Isle au Haut Planning Board Minutes of Meeting of April 21, 2016

Pomeroy PB application

Memo of Bob Gerber to Nicholas Filler April 3, 2016 Re: Application of Pomeroy for driveway across your land at Birch Point, Isle au Haut

Property lines on Google Earth 6/22/14 photo Property lines georeferenced from Sage Collins undated survey plan Grid is UTM NAD83, Zone 19N (m) RGG 4/3/16

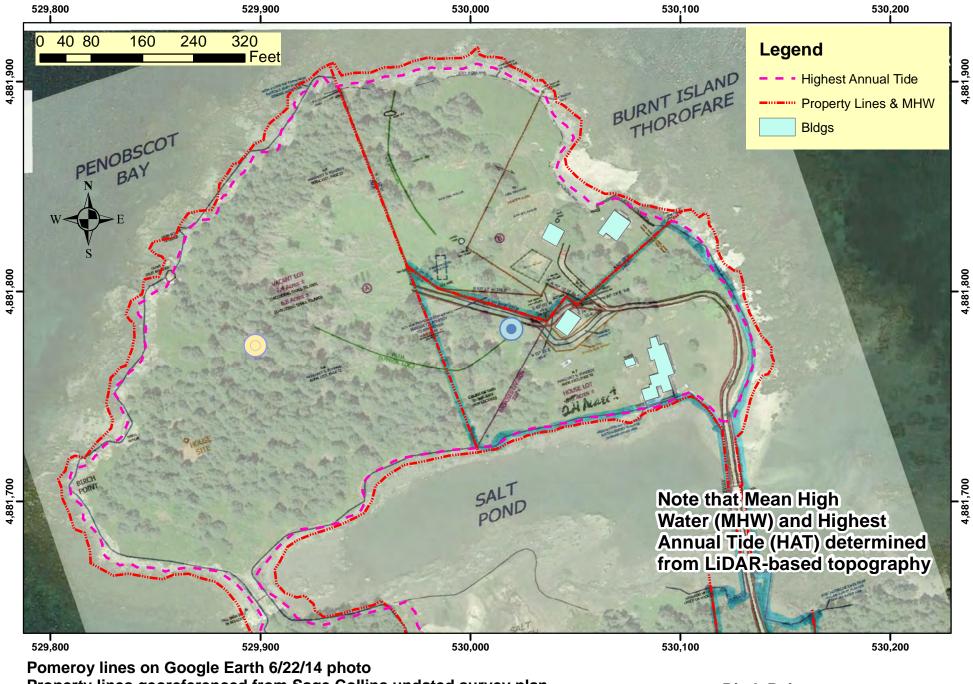
The first issue I see is that the property plan submitted by Pomeroy does not show your western property line properly. It shows the line as being what is shown on the plan you sent to me as the "proposed division" line that starts at your southwest corner on the north side of the salt pond and angles off to the northeast. It should have shown the blue line drawn on your plan, which is the line clearly called out by the deed from Pomeroy to you. I will get back to the applicant and ask that the plan be revised to correct that error.

The second issue has to do with where the new driveway would lie to the north and west of the "garage" that is on your property. The plan you sent to me showed a 4640 (?—your PDF is a little blurry, making it hard for me to discriminate all the text) square foot parcel being deeded from Pomeroy to Ann Mathias. In fact the Knox Registry records show it was conveyed at Book 4992, page 161, to Charles and Robert Mathias with an area of 4610 square feet. But beyond this small discrepancy which obviously resulted from a change between the time the sketch you sent to me was made and the time the deeds were recorded, is an issue of where the 20-ft wide driveway easement reserved by Pomeroy should be located. Your sketch seems to suggest by the parallel red lines that the road would run all on your property, just south of the new conveyance to Charles and Robert Mathias. But on the deed of Pomeroy to you, it states:

One other question: Pomeroy has retained rights to water from "the well" on your property. I see something on the sketch you sent to me that shows a "drilled well" about 70' west of the western corner of the garage. Is this the well referred to in the deed?

I strongly suggest that you have a surveyor prepare and record a standard boundary survey for the property that you bought. A surveyor should also prepare and record a plan that meets the requirements for the driveway agreement expressed in the deed from Pomeroy to you:

BirchDRIVE4-18-16.pdf 64K

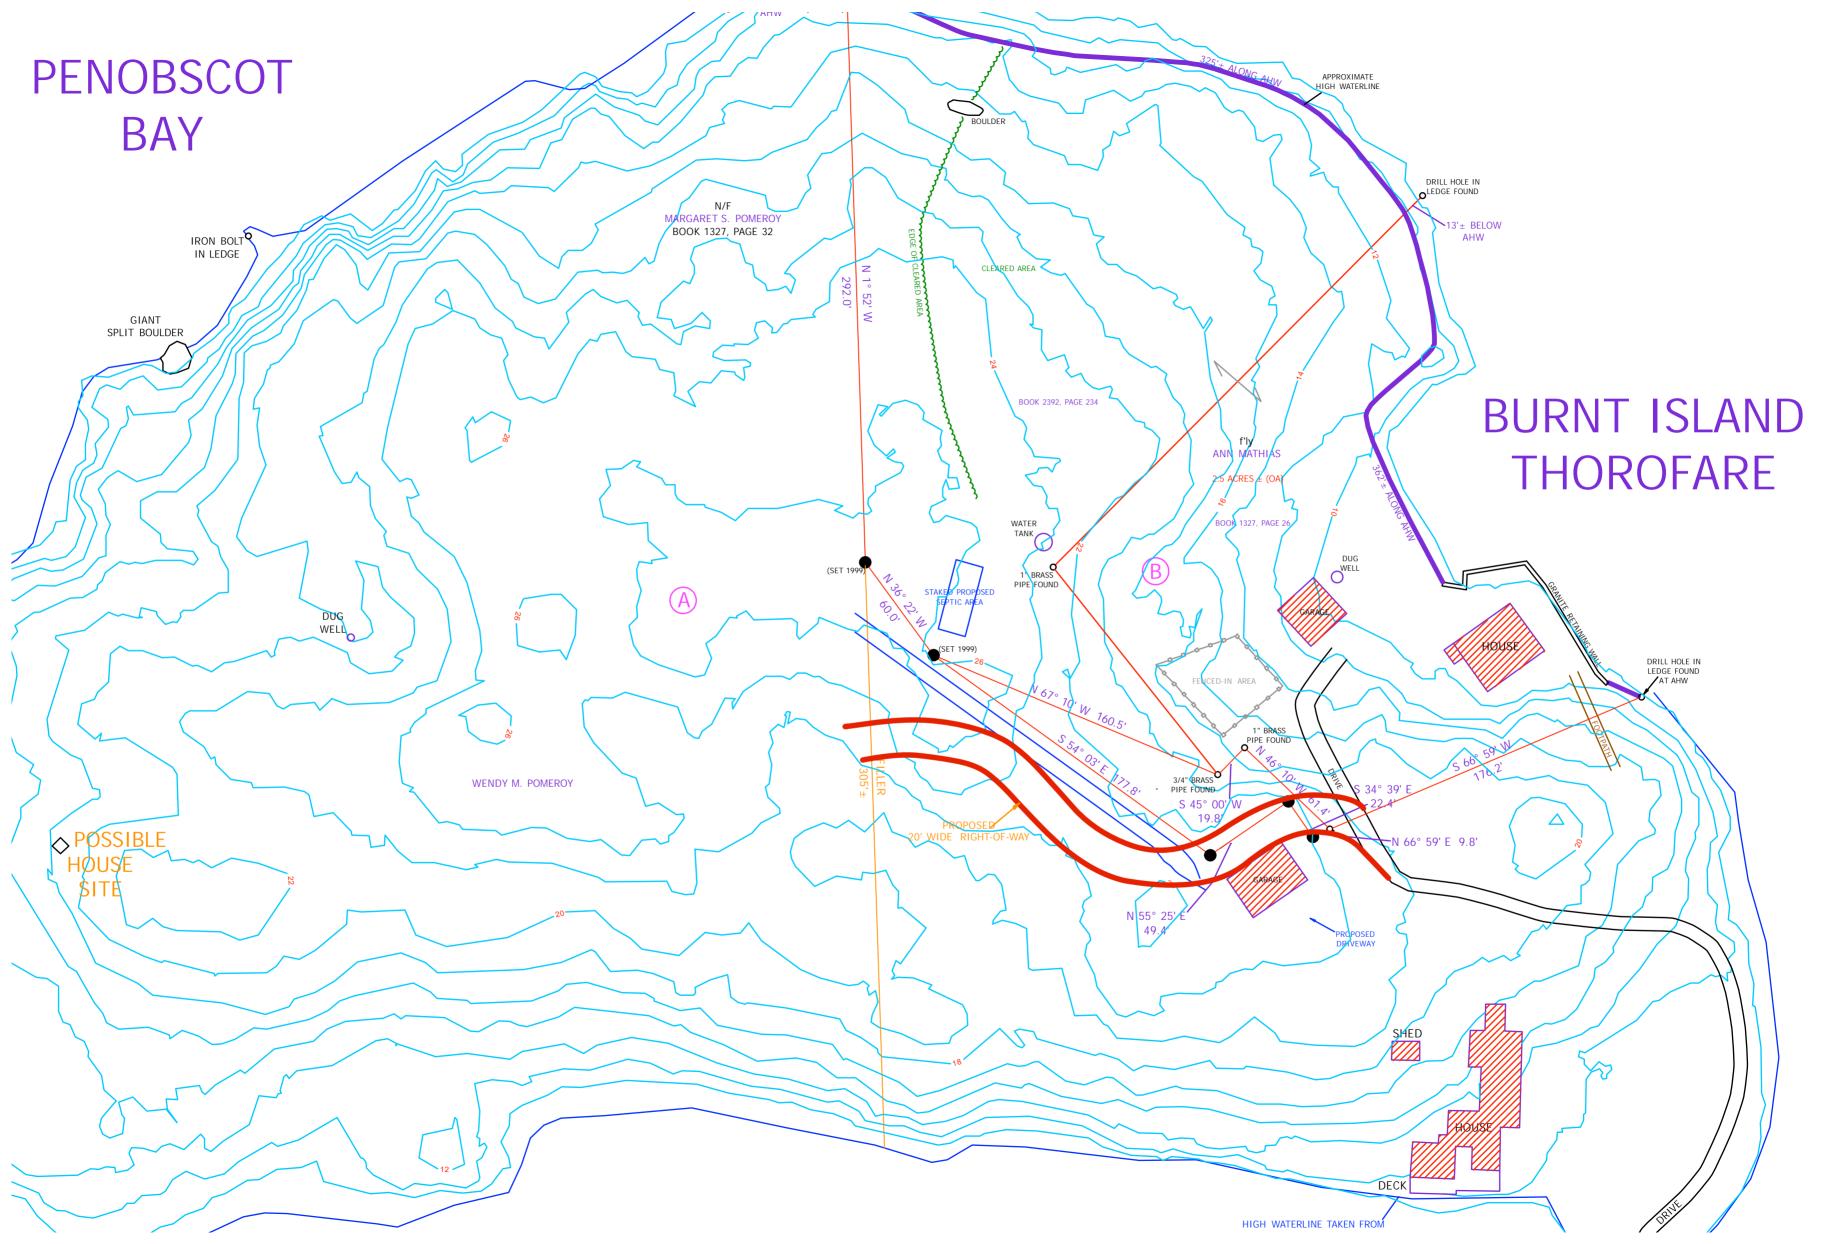
You have now shown the 20-ft driveway easement going over a corner of Ann Mathias's property so I will also need her confirmation that it is ok to cross that corner of her land (does that right already exist in her deed? If so, please send me a copy with that right highlighted).

Also, you don't show where the driveway will go in the area west of the Filler property and on your residual property. Please submit a revised plan with that portion of the driveway shown. I can't monitor compliance nor help Bill Stevens develop a sediment and erosion control plan without knowing where this is going on the face of the earth.

The route shown in the drawing is arranged to be as far from the Mathias property as possible, especially at the back of the garage, and is hopefully, a respectful distance from the Fillers. It is shown in the thick red lines. Please take a look at the drawing, and if it is good with you, send an email to Bob Gerber <a href="mailto:

What is shown on the drawing is a 20' wide right-of-way, which is apparently required. Within that ROW there will be a road,
